City of Goldsboro
Historic District
Commission
June 03, 2025

AGENDA
HISTORIC DISTRICT COMMISSION
City of Goldsboro
Tuesday, June 03, 2025, 5:30 P.M.

SUBJECT: CA-08-25 MJ – 301 S. John St./108 E. Spruce St., is located at the southwest corner of S. John and E. Spruce Streets.

SUBJECT: CA-09-25 MJ- 204 E. Chestnut St./200 S. John St., is located at the southeast corner of E. Chestnut and S. John Streets.

FLOOR PLAN
SCALE - 1/4" = 1'-0"

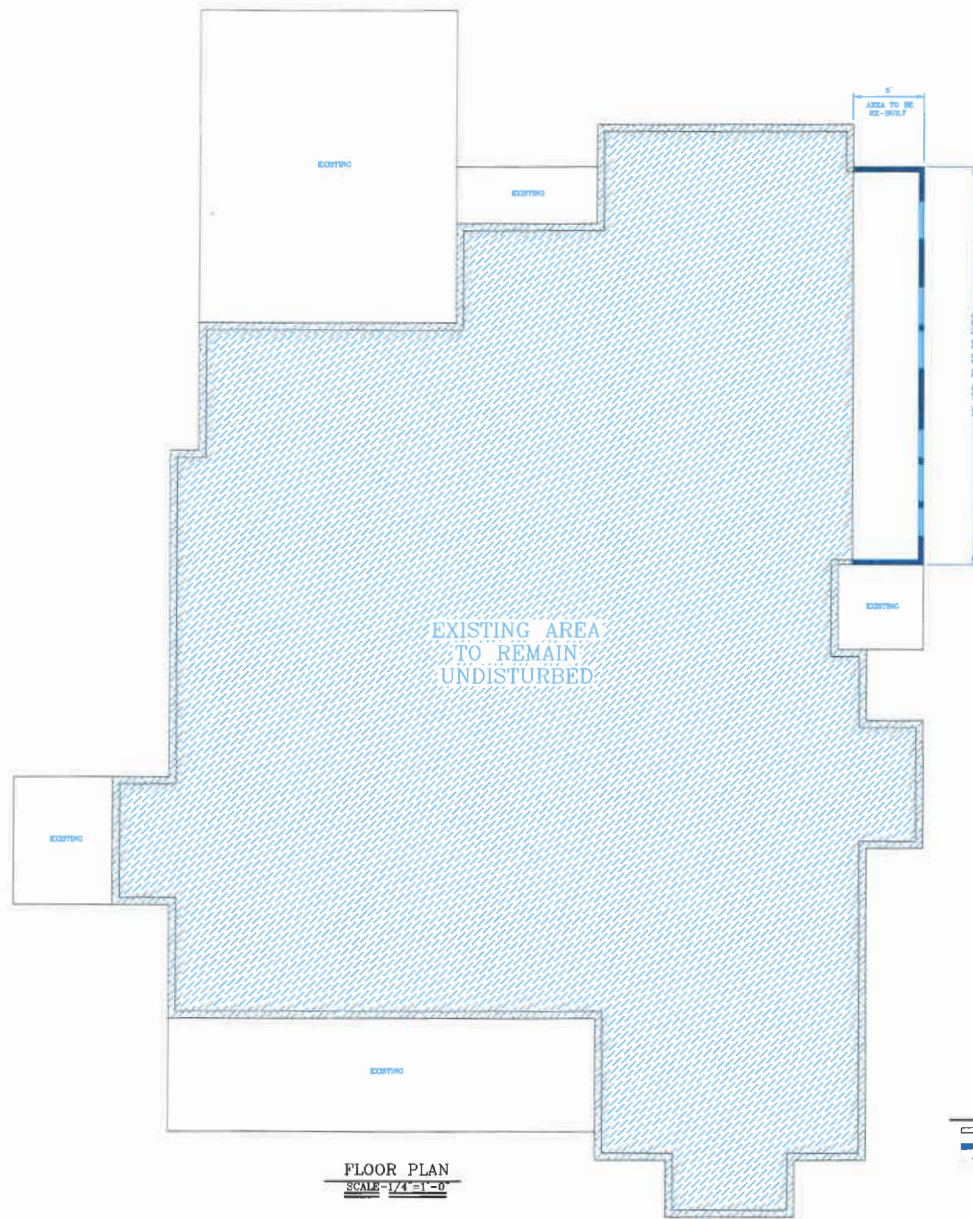
The application as currently proposed meets the Historic District Guidelines. Each building has its own particular history and architectural story to tell and therefore buildings should be considered in an individual manner. This building was constructed in Greene County, then deconstructed and moved to Goldsboro, Wayne County, where it was reconstructed with additions. The kitchen addition to the west of the main structure had a small porch on its north side (Sanborn Fire Insurance Maps 1890, 1896, 1901, 1908, 1913, 1918, 1924) that was later infilled (between 1956 and 1979). Evidence of two arched windows or doors can be seen in the existing header of the wall where the porch would have begun.

It is staff recommendation that the existing arches be left in place, should the porch and windows and/or doors be restored. Staff supports Mr. Grantham's application to reconstruct the wall that was taken down in 2024 with the same window fenestration and same materials as the original addition/infill – wood siding and wood windows and install the ornamental bracket detailing.

It is the interpretation of Planning Staff that the proposal, as submitted, is not incongruous with the Historic District Guidelines and the recommendation is that this proposal be approved with minor works be approved by city staff; however, Planning Staff are open to recommendation and guidance from the Historic District Commission.

Proposed Front Elevation

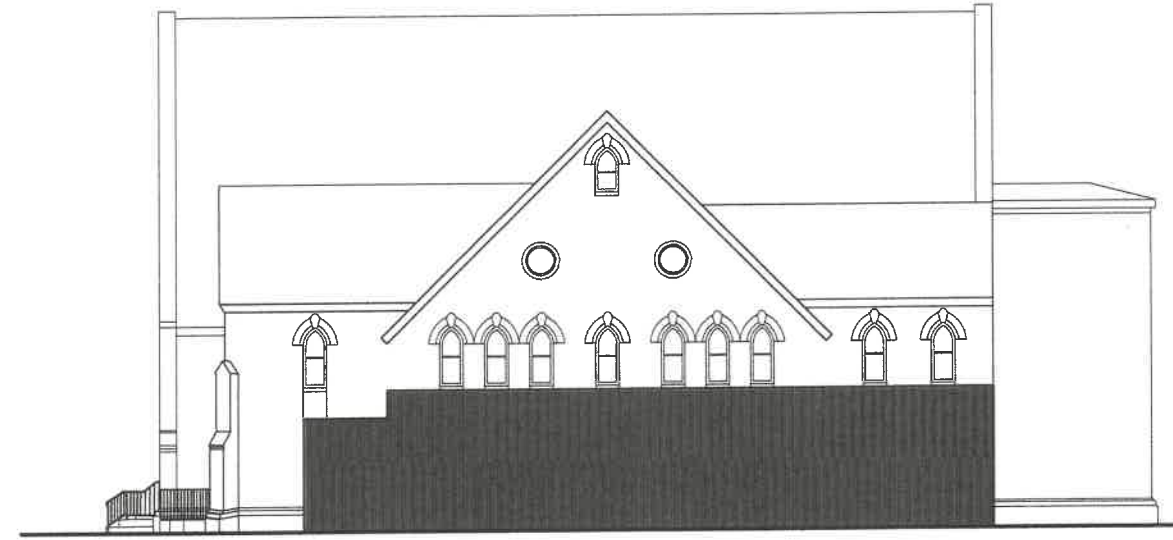
- 1) Deconstruct the existing towers and rebuild with altered architectural new construction detail.
- 2) Repair and point-up remaining masonry as necessary for structural integrity and reduction of water infiltration.
- 3) Repair and or replace rotted wood trim.
- 4) Install new flashing and caulking to ensure watertightness.

It is the interpretation of Planning Staff that the proposal, as submitted, be tabled for a length of sixty (60) days and to seek other expert advice; however, Planning Staff are open to recommendation and guidance from the Historic District Commission.
